# Japan positions/comments on UBE/UBC Measurement for HDV

prepared by Japan

11<sup>th</sup> & 12<sup>th</sup> October 2023

## multiple C-rates with proportional duration under WHVC condition

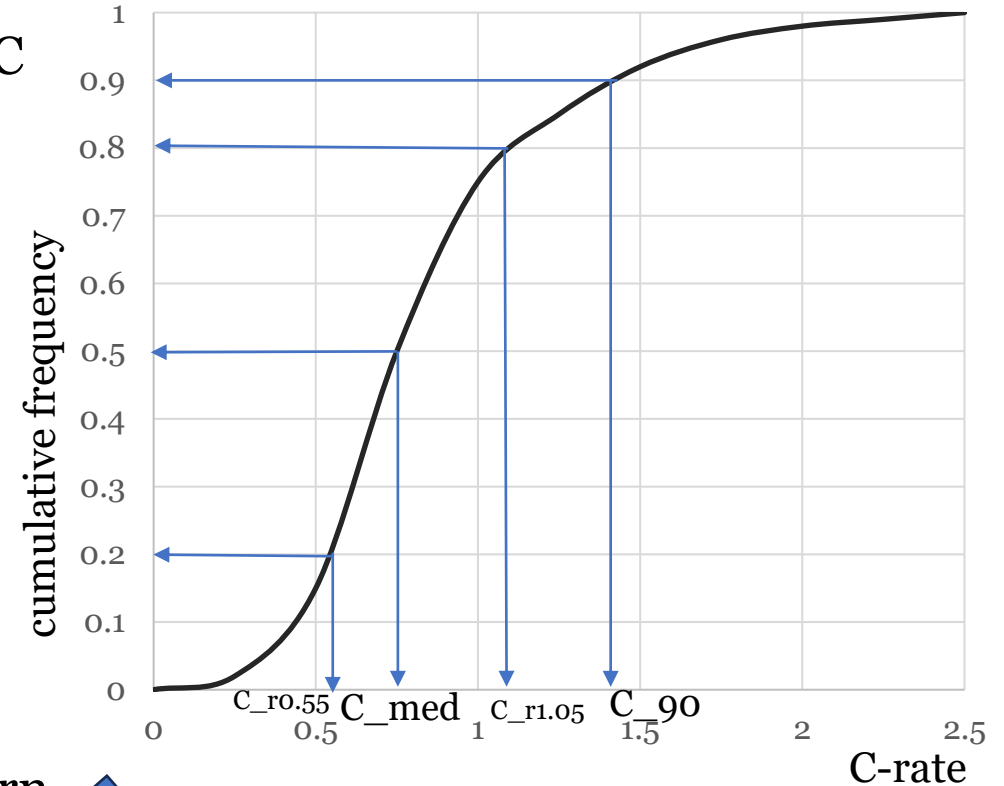
1. preferably select maximum CED\* configuration @ WHVC within Part B family
2. system power (P) needs to be defined for WHVC
3. automatically obtain the cumulative frequency against C-rate (see right figure)
4. C\_90 and C\_med shall be selected
5. additional C-rates may be selected (no limitation)
6. higher C-rate covers lower C-rate duration
7. OK to split each C-rate duration

sample : discharge pattern

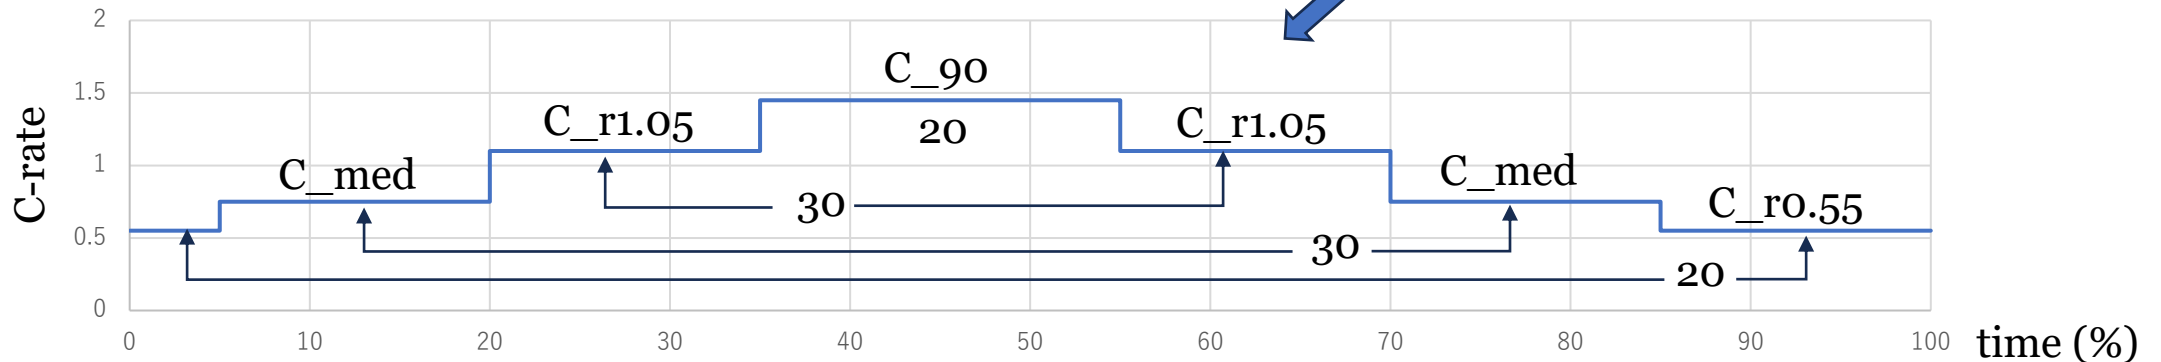
1. To decide if UBE or UBC shall be measured: **UBE more favourable by CP**
2. To decide if applying discharge or charge measurements: **discharge more favourable by CP**
3. Current measured, Voltage measured, on-board data with equivalence of results, accuracy ... Availability of inspection point
